PX30 - Bug #433

KB19B

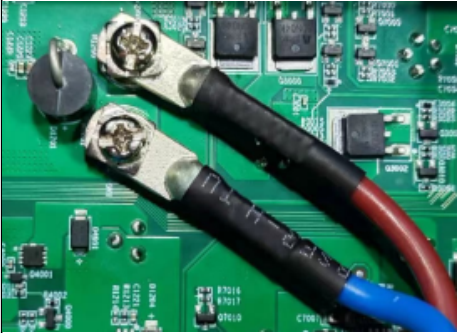
8mm
